HARTZELL PROPELLER INC.

ALERT SERVICE BULLETIN

HC-ASB-61-395

A-2418-15 Pitch Change Rod

Pitch Change Rod Replacement
Figure 1

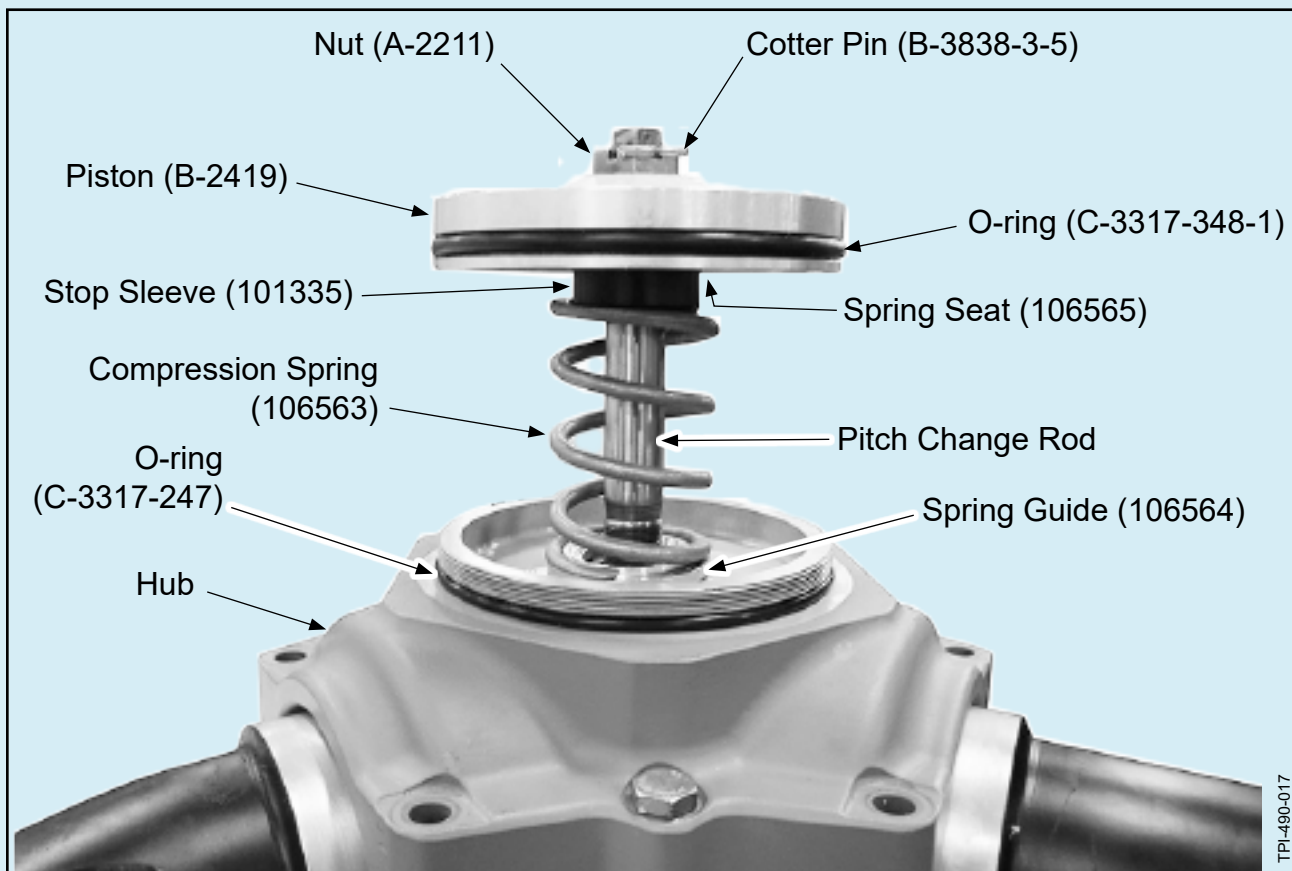
- (1) The chamfer on the A-2418-2 pitch change rod used on the affected propellers can cause wear on the C-3317-115-1 O-ring resulting in oil leakage around the pitch change rod.
- (2) Hartzell Propeller Inc. is introducing the A-2418-15 pitch change rod as a replacement for the A-2418-2 pitch change rod on the affected propellers to prevent wear on the C-3317-115-1 O-ring.
 - (a) The A-2418-15 pitch change rod is approximately 0.58 inch (14.7 mm) longer than the A-2418-2 pitch change rod.
 - 1 Due to the additional length, the chamfer on the A-2418-15 pitch change rod will not contact the C-3317-115-1 O-ring.

B. A-2418-2 Pitch Change Rod Removal
(Refer to Figure 1)

C. A-2418-15 Pitch Change Rod Installation

- (1) This procedure must be performed by a certified propeller repair station with the appropriate rating.
- (2) Install the O-ring (C-3317-115-1) in the groove on the ID of the engine-side hub bushing.

- (3) Apply anti-seize compound CM118 to the threads of the pitch change rod (A-2428-15).
- (4) Insert the pitch change rod (A-2418-15) through the cylinder-side half of the hub and into the fork.

- (5) Torque the pitch change rod (A-2418-15) to 36-44 Ft-Lbs (49-59 N•m) wet.
- (6) Piston and Cylinder Installation:
 - (a) Using lubricant CM12, lightly lubricate the spring guide (106564) and put it on the hub over the pitch change rod bore hole.

**Cotter Pin Installation
Figure 2**

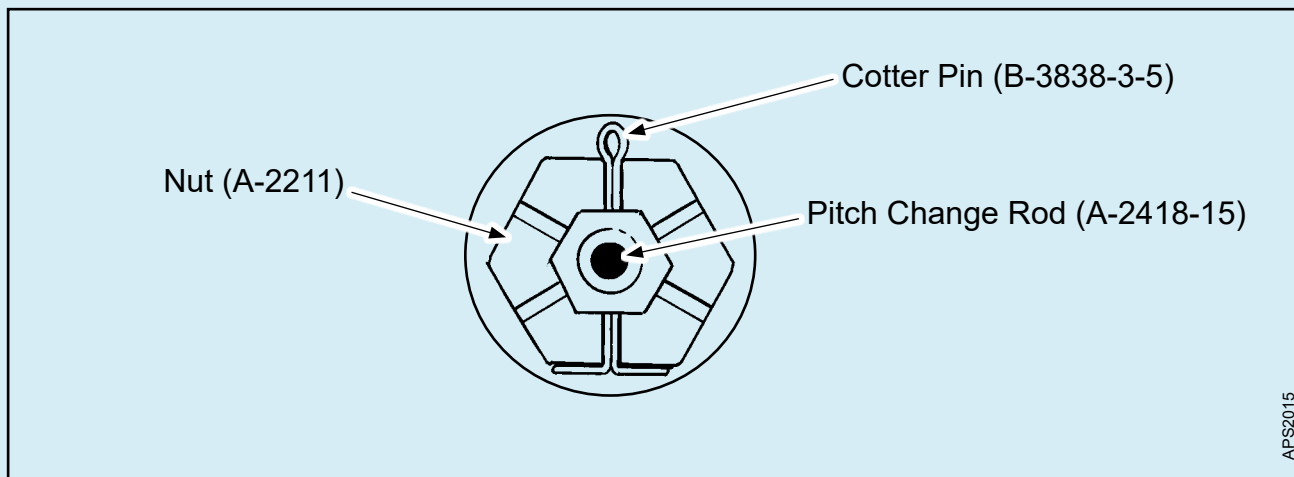
CAUTION: DO NOT BEND THE TABS OF THE COTTER PIN (B-3838-3-5) OVER THE END OF THE PITCH CHANGE ROD (A-2418-15). COTTER PIN TABS BENT OVER THE END OF THE PITCH CHANGE ROD INTERFERE WITH THE LOW PITCH STOP SCREW (102472).

- (l) Safety the nut (A-2211) with the cotter pin (B-3838-3-5) as shown in Figure 2.

Installing the Cylinder
Figure 3

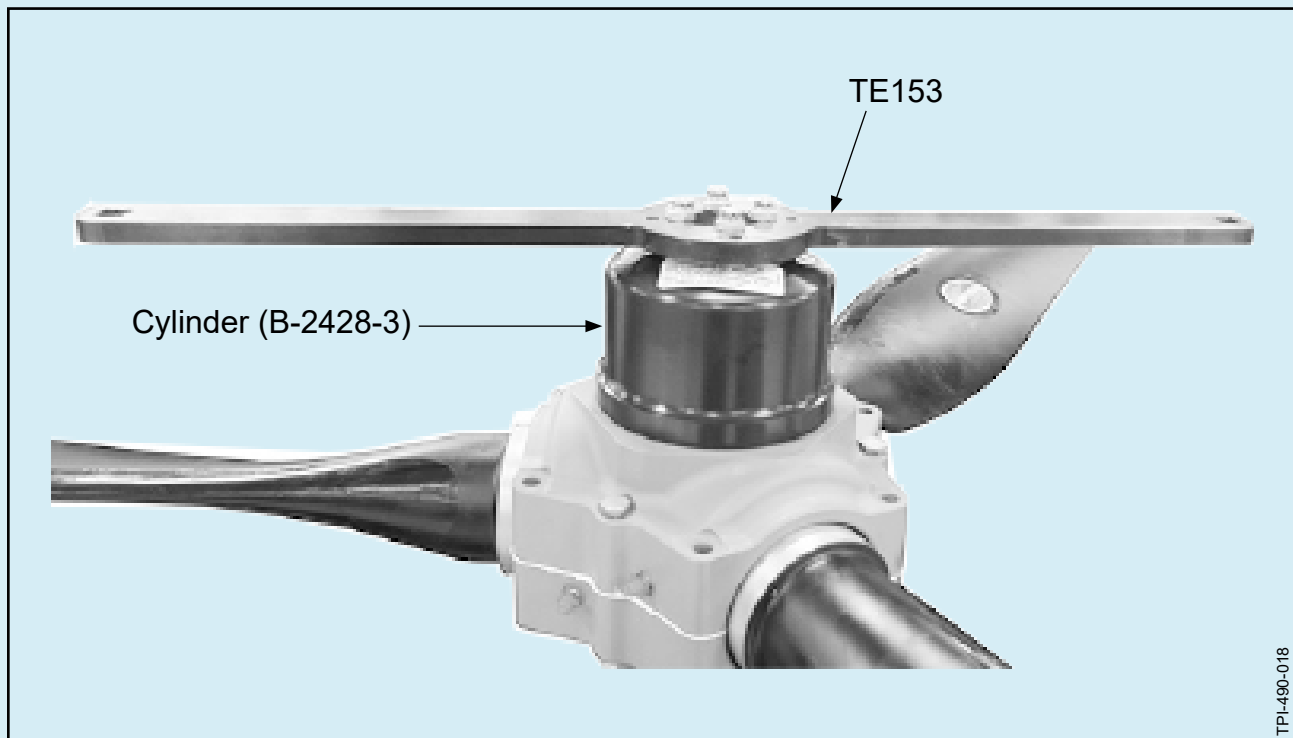
- (x) Install the cylinder (B-2428-3) onto the hub.
 - (y) Using four 1/4-28UNF-3B bolts or screws, attach the cylinder torque wrench adapter TE153 to the cylinder (B-2428-3). Refer to Figure 3.
 - (z) Torque the cylinder (B-2428-3) to 120-150 Ft-Lbs (163-203 N•m) wet.
- (7) Make an entry in the propeller logbook indicating installation of the A-2418-15 pitch change rod as terminating action for this Alert Service Bulletin.
- (8) Install the propeller onto the aircraft in accordance with Hartzell Propeller Inc. Raptor Series Reciprocating Propeller OwnersManual 480 (61-10-80).
